# UNITED STATES PATENT AND TRADEMARK OFFICE

APPLICATION NO.	FILING DATE	FIRST NAMED INVENTOR	ATTORNEY DOCKET NO.	CONFIRMATION NO.
09/759,579	01/12/2001	Robert F. Heard	91805001	1809

# Office Action Summary

FIG. 7

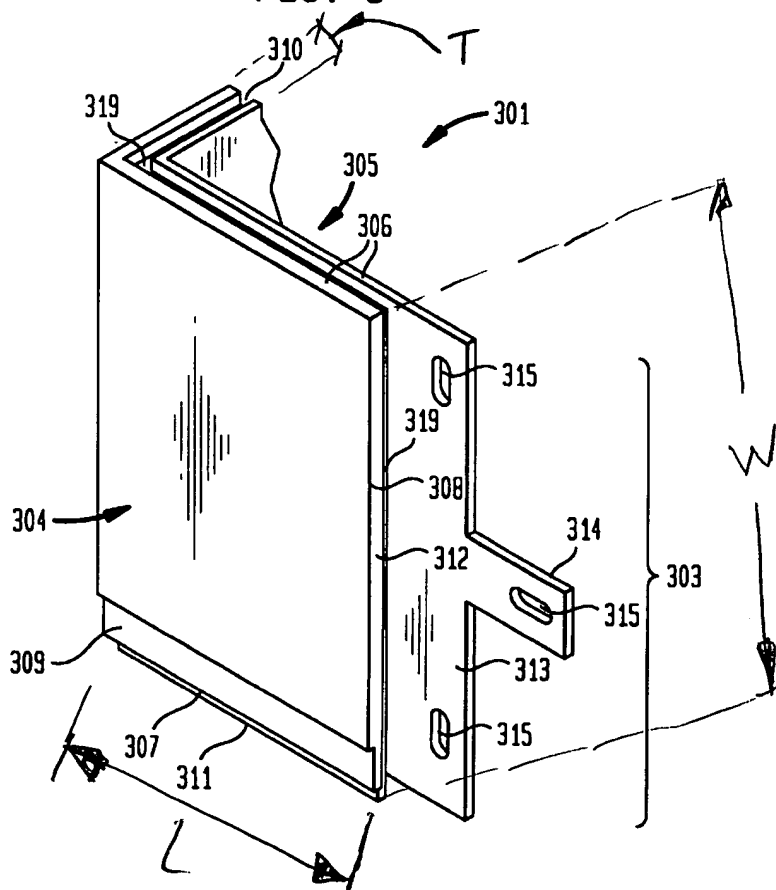
Claims 1,2,4,5,7-11 and 20 are rejected under 35 U.S.C. 103(a) as being unpatentable over US Patent #5,836,123 to GULINO. Regarding claims 1 and 20, GULINO discloses the use of a decorative member (701,801) including a solid rectangular portion not shown but similar to rectangular wing portions (303) each having a length (L) that is greater than a width (W) thereof, and a thickness (T). The rectangular portion further includes a top surface (704,804) and a bottom surface (705,805) wherein the

bottom surface (705,805) overlies the building as shown in figure 1. The decorative member of GULINO also includes a flange portion (713,714) and (818) in parallel relationship with the bottom surface (705,805); wherein the flange (713,714) and (818) extend beyond the width (W) of the rectangular portion. GULINO also discloses the use of a channel (710,810) formed between the flange portion (713,714) and (818) and the top surface (704,804) wherein the channel is adapted to receive a siding member (S), see the marked attachment. GULINO discloses the basic claimed decorative member except for explicitly detailing that his member is a "brickmold" and except for detailing the sidings of two differing thickness may be accommodated by the channel. Although GULINO does not explicitly detail his decorative member as being a "brickmold", he does detail that his decorative member is a corner trim piece. Corner trim pieces, trim pieces, and brickmolds are art recognized equivalents for their use in providing external decorative devices to a structure. Further, the applicant is reminded that the manner in which a device is employed does not differentiate the claimed device from a prior art apparatus satisfying the same structural limitations. Hence, although the device of GULINO is a corner trim device, it is a trim device that satisfies all of the structural limitations of the claimed apparatus. In regards to the siding thicknesses, due to the step portion (colored red in the marked attachment of figure 8), it would have been obvious to one having ordinary skill in the art at the time the invention was made that the channel (710,810) is fully capable of being adapted to receive a siding have differing thicknesses. In reference to claim 2, the decorative device of GULINO includes a

art in a cellular form and a resinous form. The selection of either would have been an obvious matter of design choice. Both cellular and resinous PVC plastics have similar properties or characteristics and function similarly. Hence, the selection of either would have been well within the general skill of a worker in the art. In further regards to claim 20, GULINO also discloses the use of a step portion, colored red in the marked attachment.
